**TSG-RAN Meeting #13
Beijing, China, 18 - 21 September 2001**

RP-010538

Title: Agreed CRs (Release '99 and Rel-4 category A) to TS 25.303

Source: TSG-RAN WG2

Figure 37: Combined Hard Handover and SRNS relocation (seamless radio bearers)

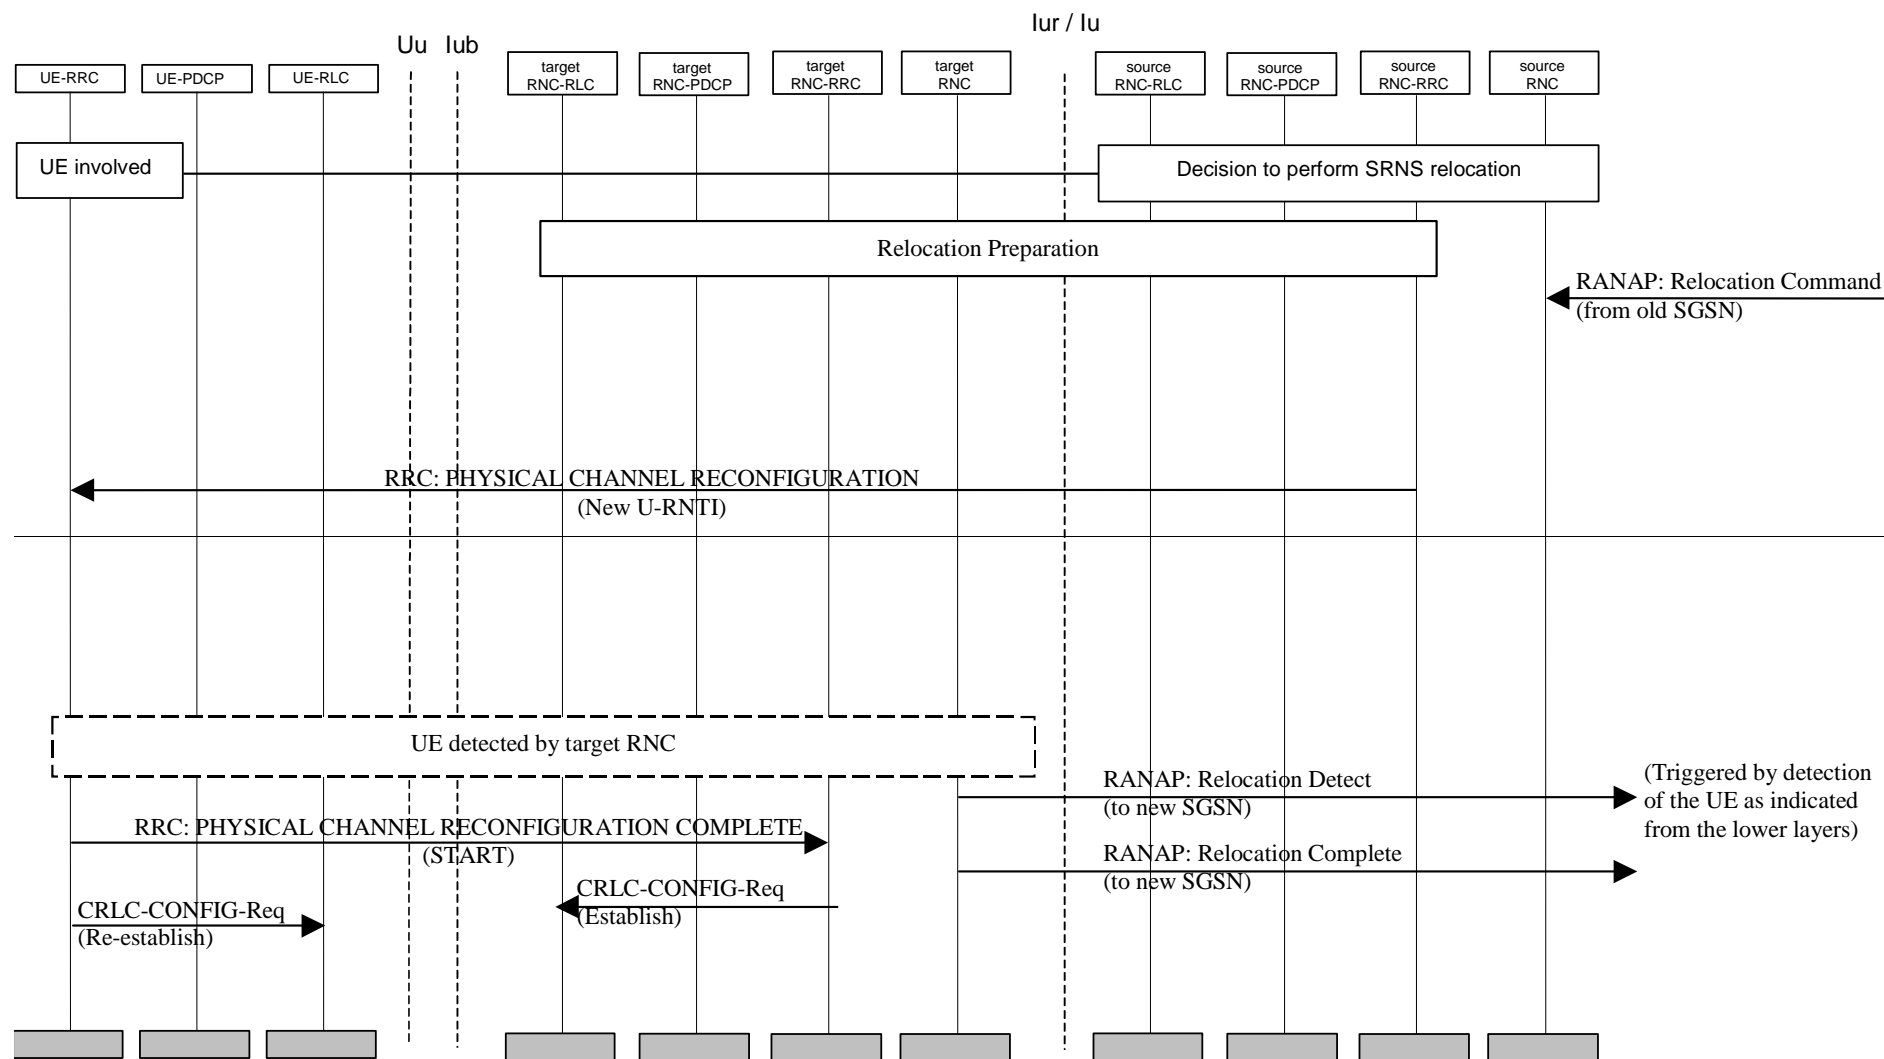
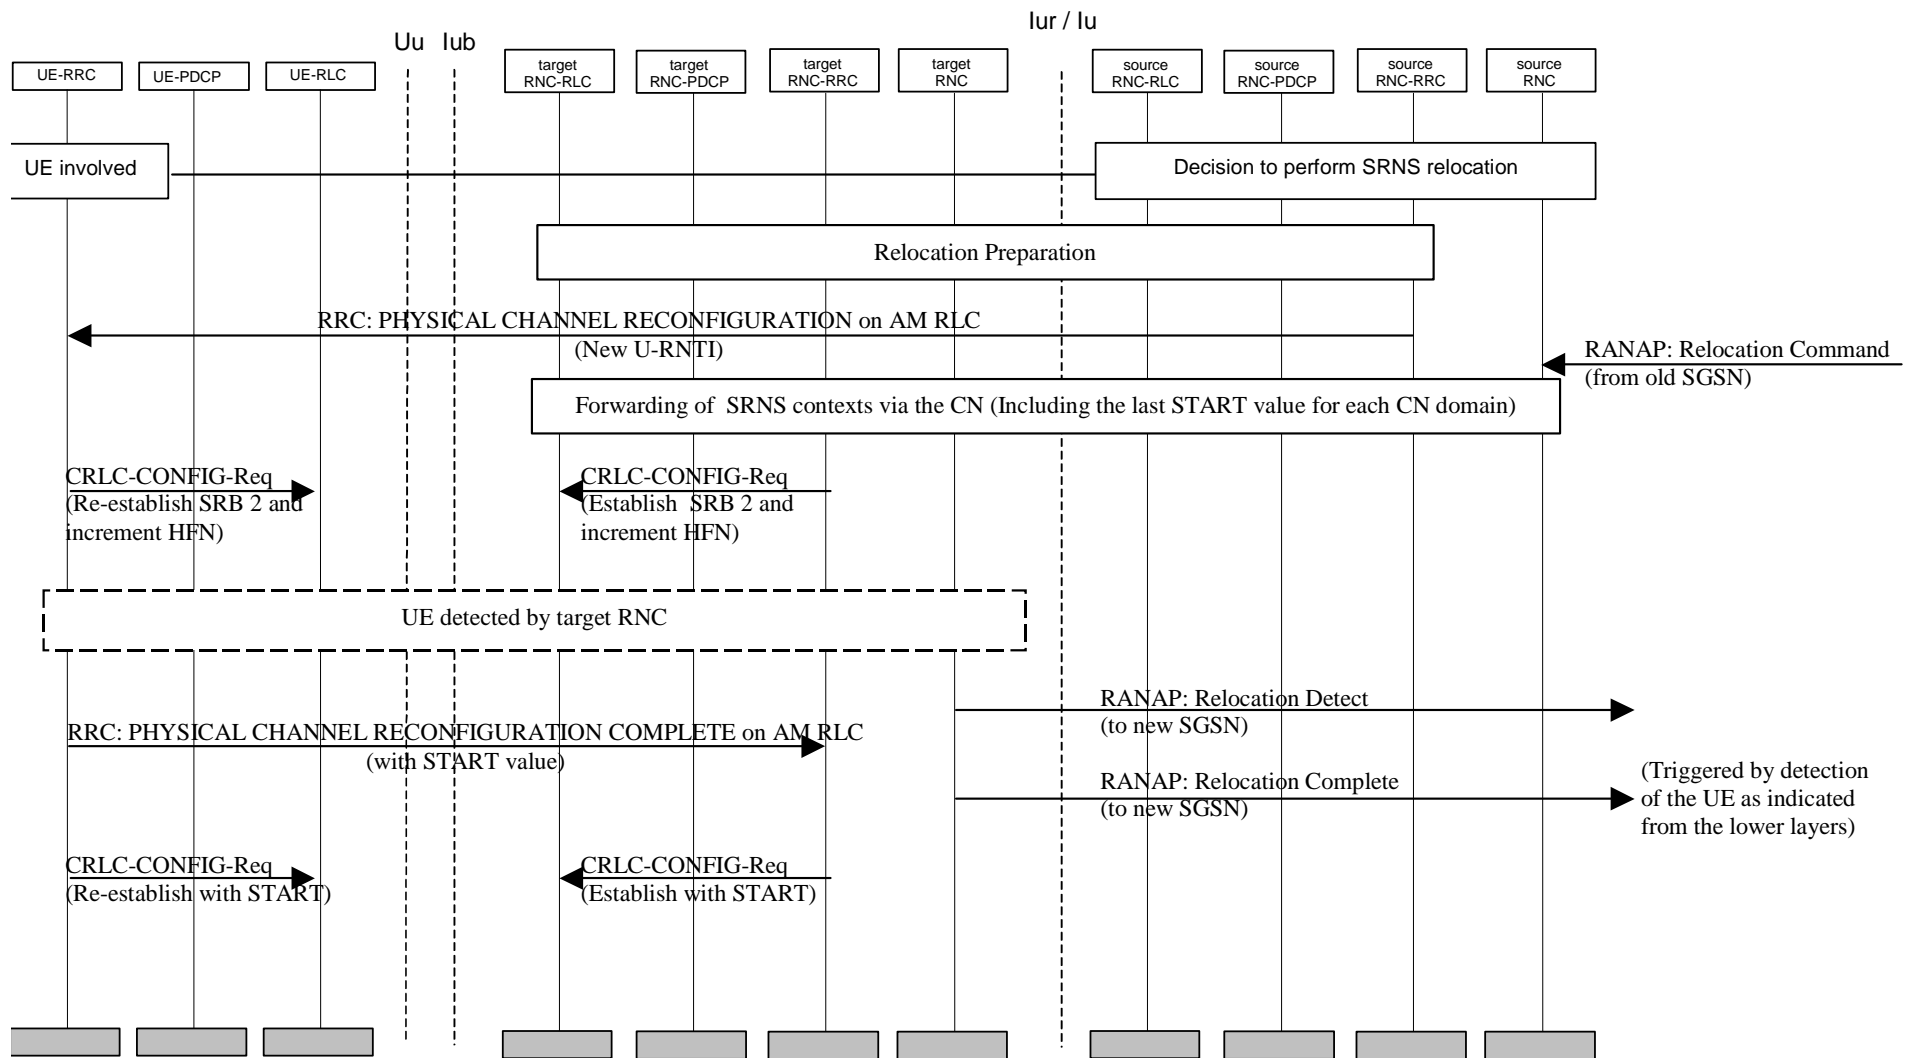
Reason for change:	⌘ In the way the current description is specified, it is not possible for the target RNC to receive the uplink response from the UE since the RLC state was lost during SRNS relocation. For this message to go through, at least the RB on which the message needs to be re-established using a START value that is known both at the UE and in UTRAN.
Summary of change:	⌘ It is suggested to perform RLC re-establishment of SRB2 before transmitting the response on the uplink. Then, after the response message is transmitted, to use the START value transmitted in this message to re-establish the rest of the RBs and SRBs.
	This change affects lossless and seamless SRNS relocation in CELL_DCH.
	The CR has isolated impact and should be seen as a correction.
Consequences if not approved:	⌘ SRNS relocation, lossless or seamless will not work in dedicated mode.

Upon reception and acknowledgment by the UE of the PHYSICAL CHANNEL RECONFIGURATION message, the RLC entity for the acknowledged mode dedicated signalling radio bearer (SRB #2) is re-establishedies, both on the UTRAN (target SRNC) and UE sides, are re-established and their HFN values are set to the knowncurrent downlink and uplink HFN-START values incremented by one. Care should be taken by UTRAN in timing the SRNS relocation so that there is no risk of a SN rollover on SRB #2 during this procedure.

If the UE has successfully configured itself, it shall send a response message, in this case PHYSICAL CHANNEL RECONFIGURATION COMPLETE message to the target RNC using the acknowledged mode dedicated signalling radio bearer (SRB #2). This message will beis transmitted based on the new RLC context and; contains the START values (to be used in integrity protection and in ciphering on radio bearers using UM and AM RLC).

Upon acknowledgement of the message, the RLC entities for the rest of the affected radio bearers are re-establishedFor the affected radio bearers, the RLC entity is re-established [2] both on the UTRAN and UE side. The HFN values for each RB are set to the START value in the message for the corresponding CN domain. with the current configuration. The HFN values for each remaining signalling radio bearers (other than SRB #2) are set to the START value in the message for the last configured CN domain.

Figure 35: Combined Hard Handover and SRNS relocation (lossless radio bearers)

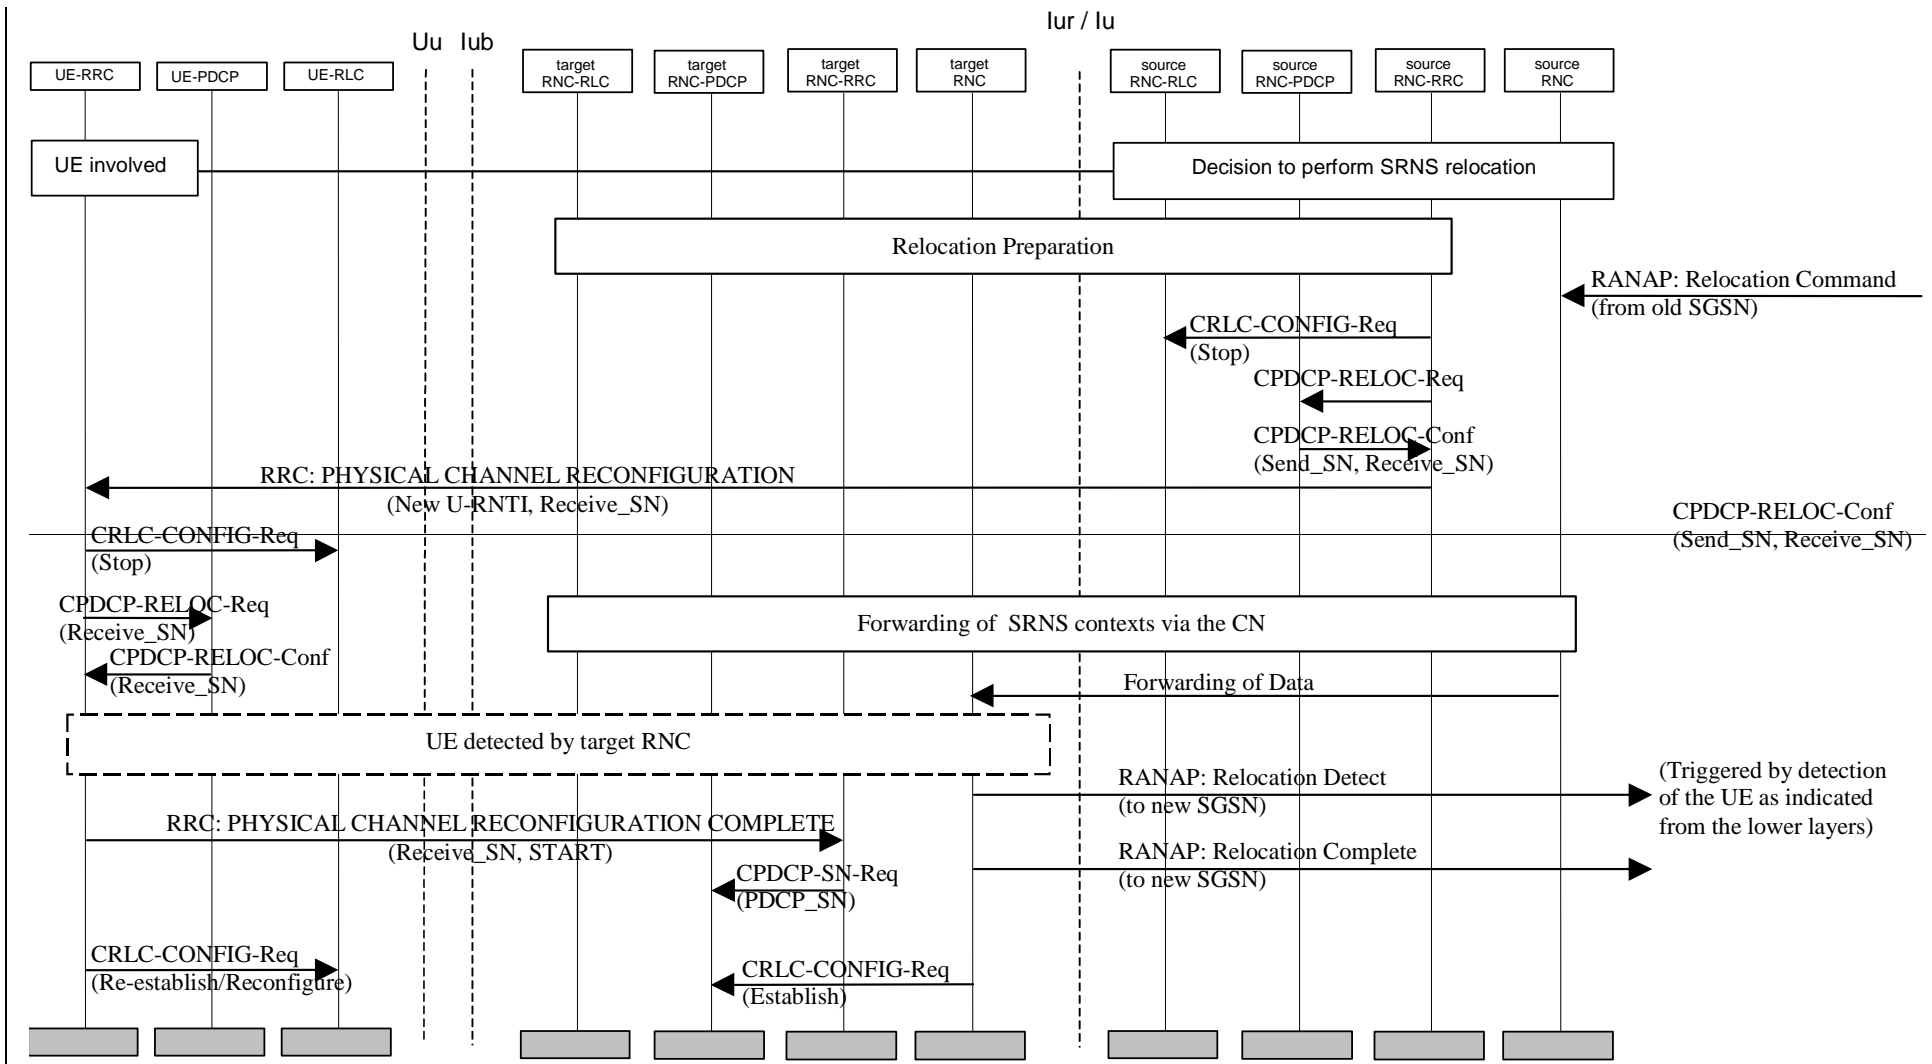
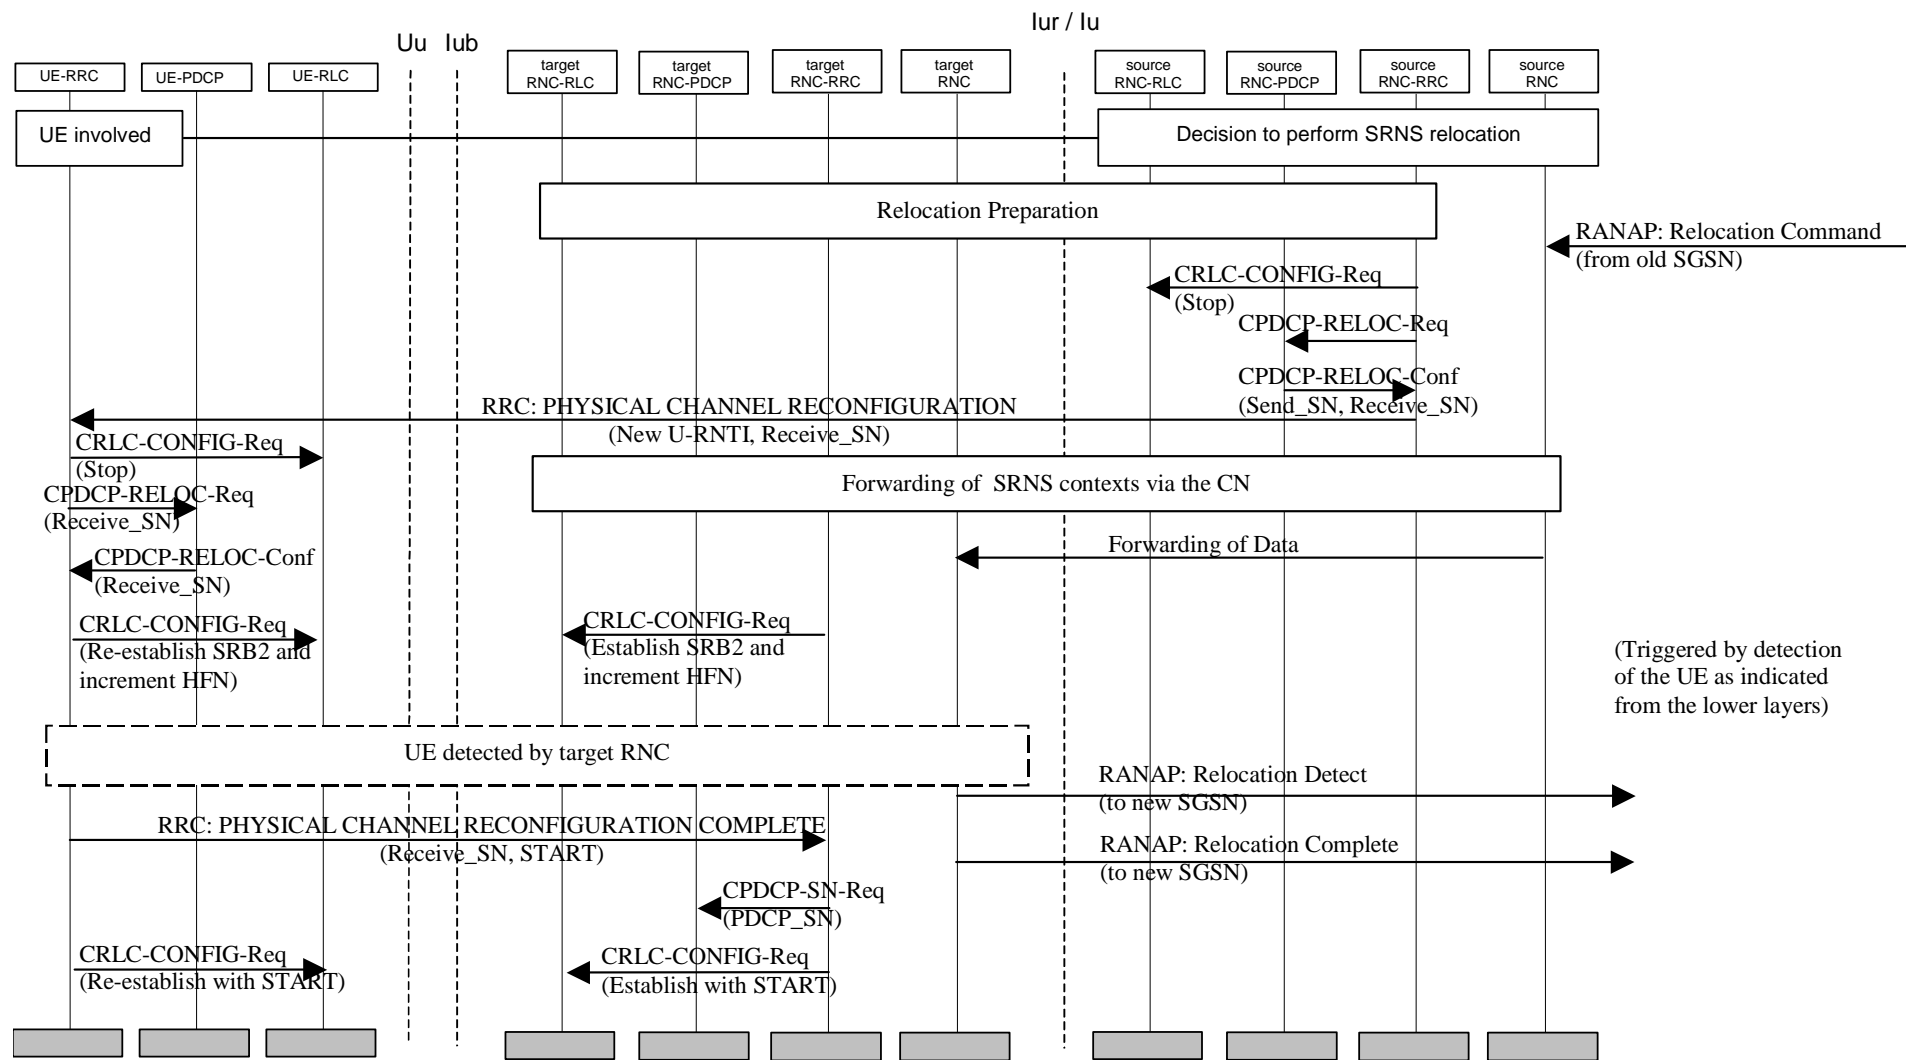
Reason for change:	⌘ In the way the current description is specified, it is not possible for the target RNC to receive the uplink response from the UE since the RLC state was lost during SRNS relocation. For this message to go through, at least the RB on which the message needs to be re-established using a START value that is known both at the UE and in UTRAN.
Summary of change:	⌘ It is suggested to perform RLC re-establishment of SRB2 before transmitting the response on the uplink. Then, after the response message is transmitted, to use the START value transmitted in this message to re-establish the rest of the RBs and SRBs. This change affects lossless and seamless SRNS relocation in CELL_DCH.
Consequences if not approved:	⌘ SRNS relocation, lossless or seamless will not work in dedicated mode.

~~For the affected radio bearers, the RLC entity is stopped and the PDCP sequence numbers are retrieved by RRC. The PDCP send and receive sequence numbers and the last START current downlink and uplink HFN values received from the mobile are then transferred via the CN during the forwarding of SRNS contexts, via the CN phase from source to target RNC for RABs that support lossless SRNS relocation. The target RNC becomes the serving RNC when the RANAP Relocation Detect message is sent.~~

Upon reception of the RANAP Relocation Command, the RRC entity in the source RNC stops the RLC entities for the affected radio bearers and retrieves the PDCP sequence numbers. It then triggers the execution of the relocation of SRNS by sending the RRC message to the UE using the acknowledged mode dedicated signalling radio bearer (SRB #2). This message includes the new U-RNTI (from the target RNC) and the uplink receive PDCP sequence number for each radio bearer configured to support lossless SRNS relocation (from the source RNC). The UE compares the uplink receive PDCP sequence number with the uplink send PDCP sequence number. If this confirms PDCP SDUs successfully transferred before the start of relocation i.e. already received by the source RNC then these are discarded by the UE.
